SAFETY RECALL BULLETIN

NHTSA RECALL 24V645

AUTOCAR, LLC DC-2406

Autocar, LLC has determined that certain DC (Legend) vehicles equipped with a horizontal exhaust diffuser may be directing the exhaust toward the CNG fuel tank.

Figure 2, View From The Rear Of The Truck

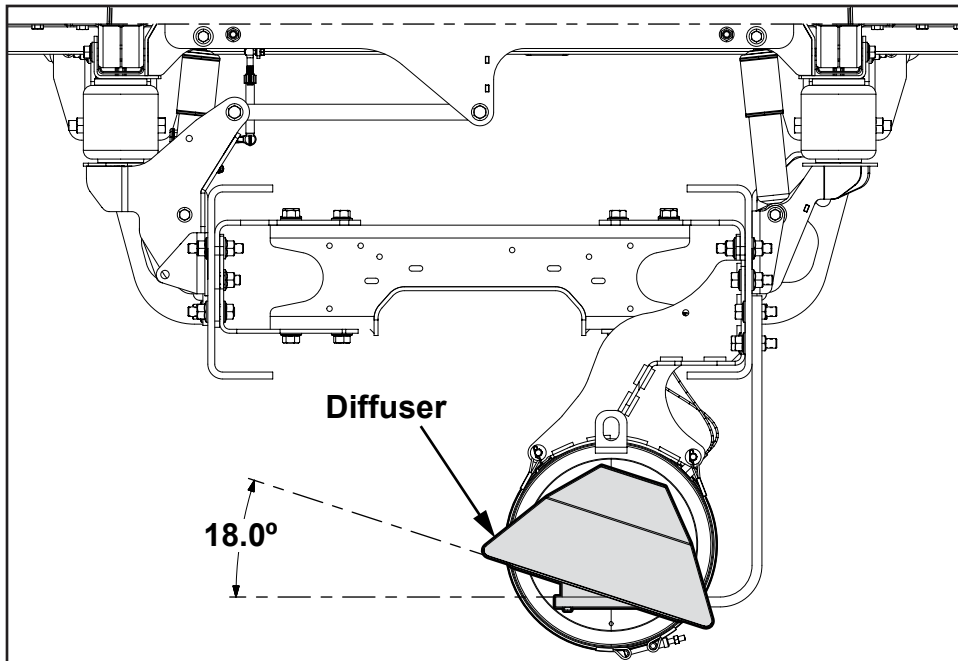
4. Inspect the diffuser and verify that it is directed away from the fuel tank at approximately 18 degrees (see *Figure 2*).

Figure 3.

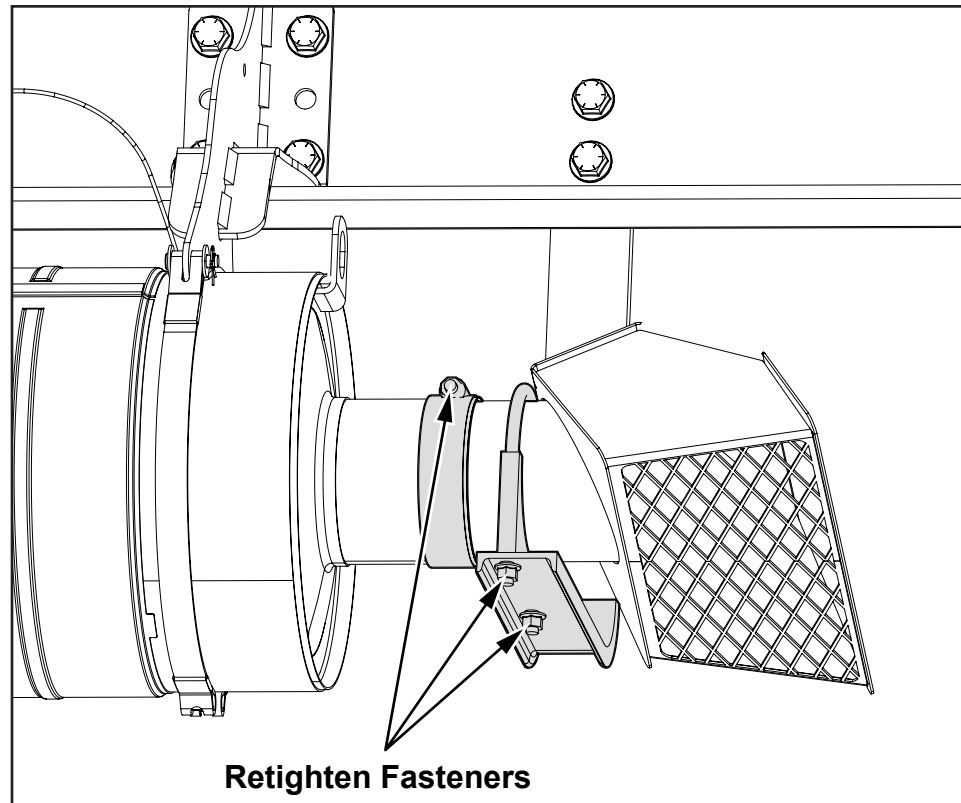
5. If the diffuser is not oriented properly, loosen the fasteners on the clamps and rotate the diffuser until the correct alignment is obtained. Then, re-tighten the fasteners (see *Figure 3*).
